City of Alameda, California

Cross Alameda Trail Ralph Appezato Memorial Parkway Improvements

PROJECT NUMBER P.W. 03-18-11

ADDENDUM NO. 02

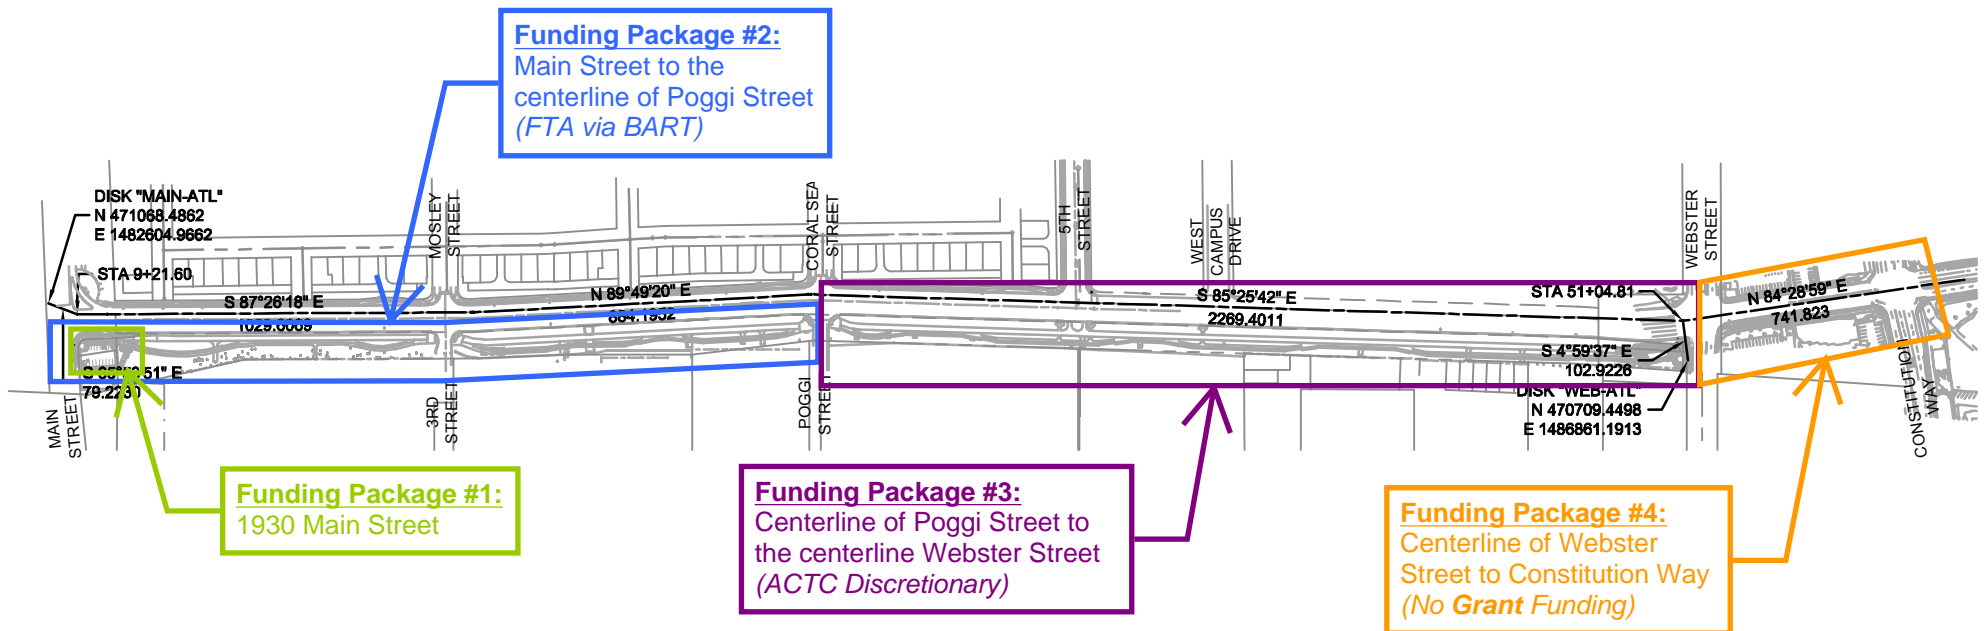
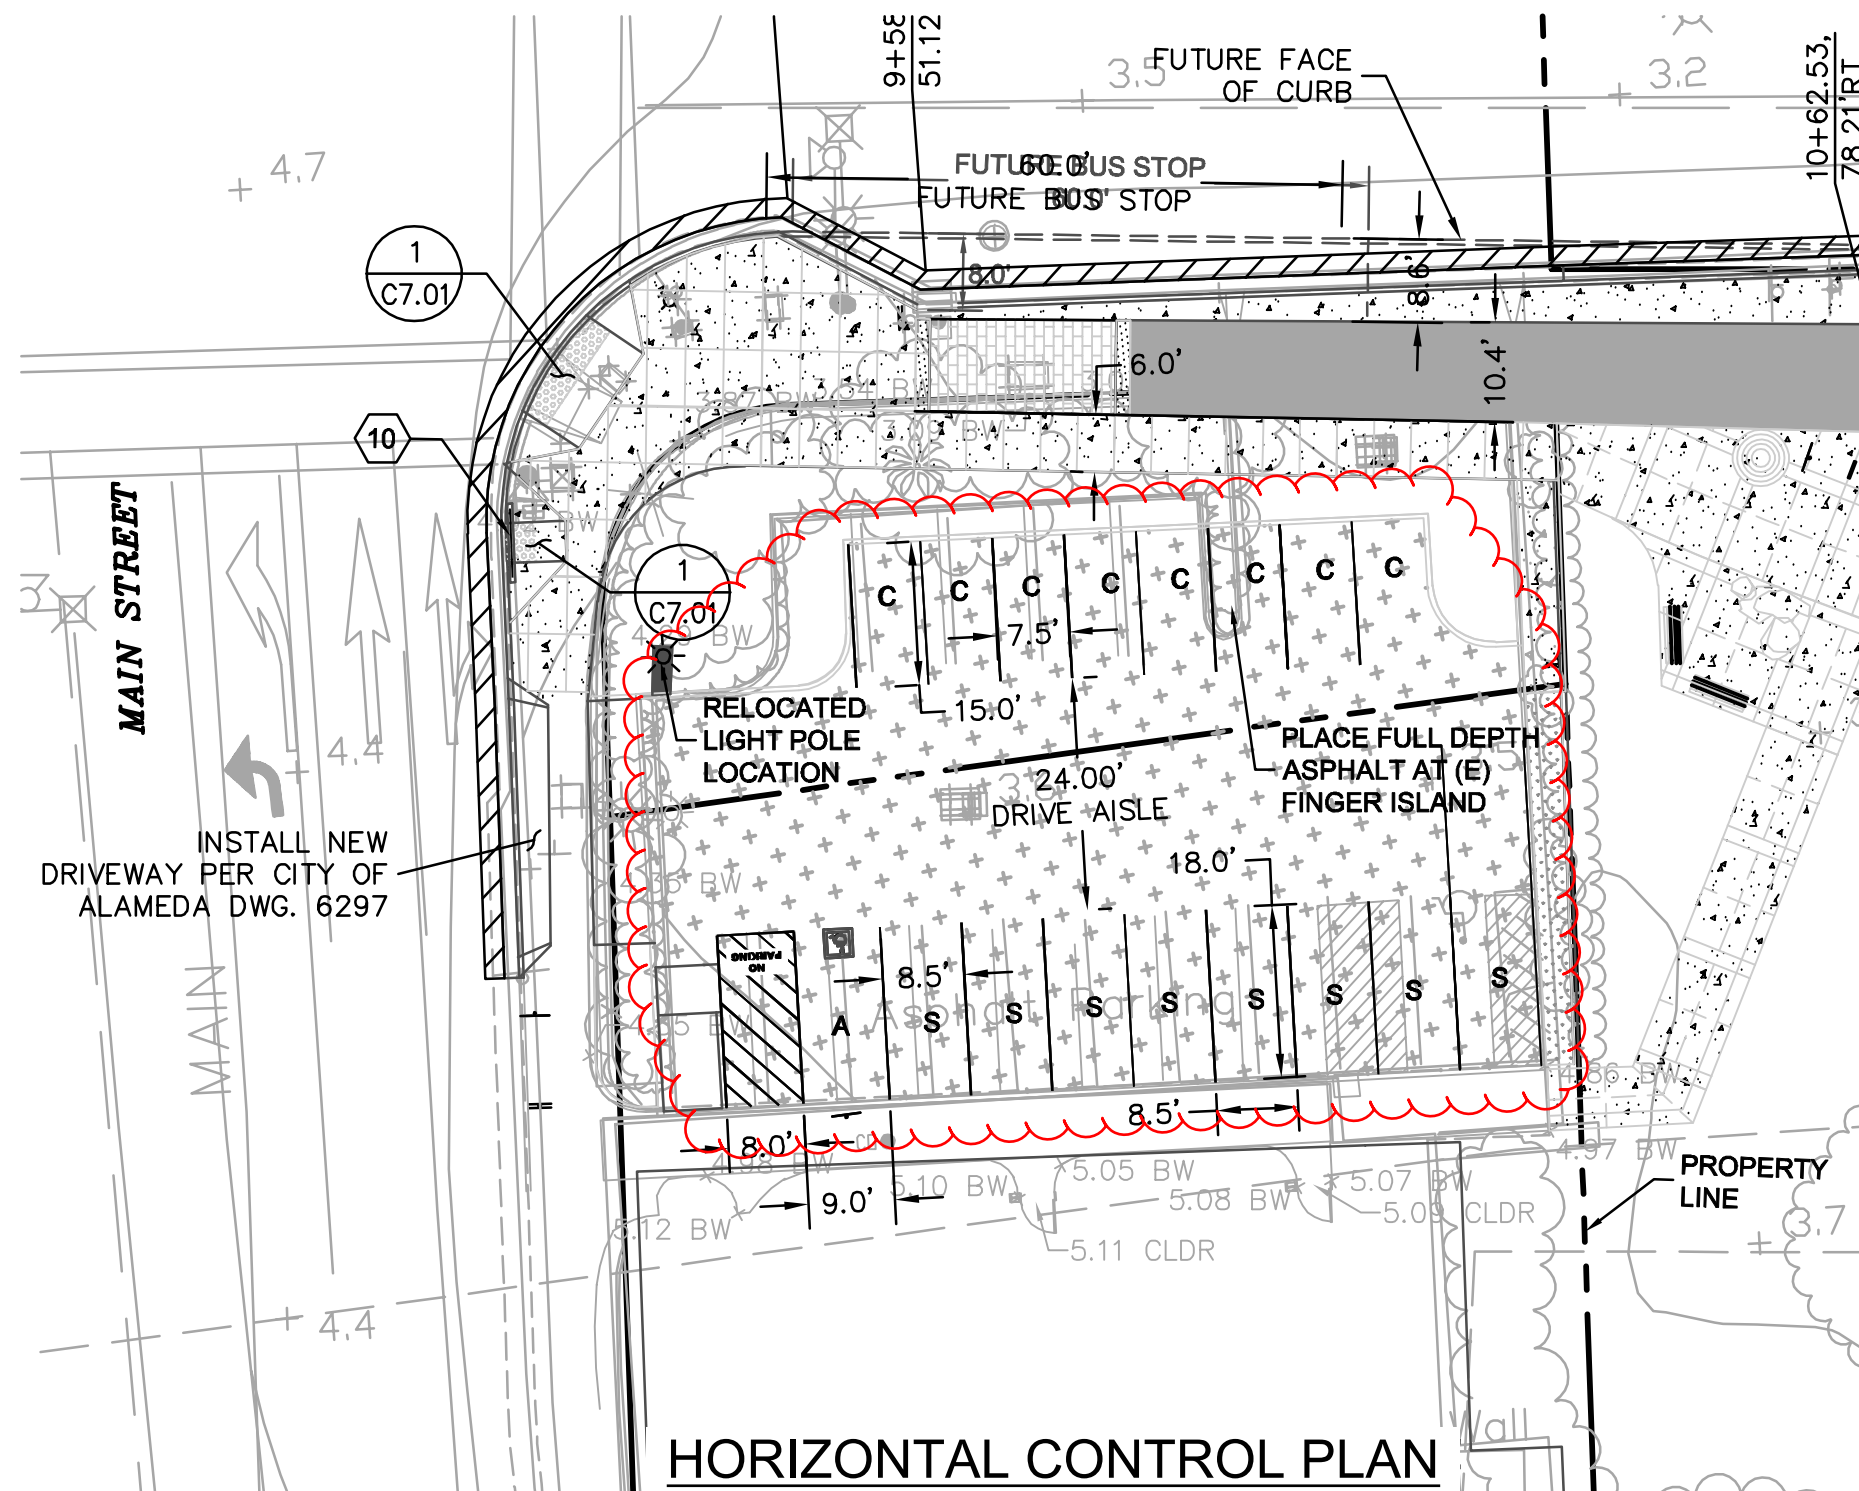
- 1) See attached updated **BASE BID SCHEDULE**. Updates include a) deletion of Funding Package #5, items (202, 203) reincorporated into **FUNDING PACKAGE #4 and #3** respectively, and b) re-naming of Funding Package #1 from 'Donut Shop' to "**1930 Main Street**".
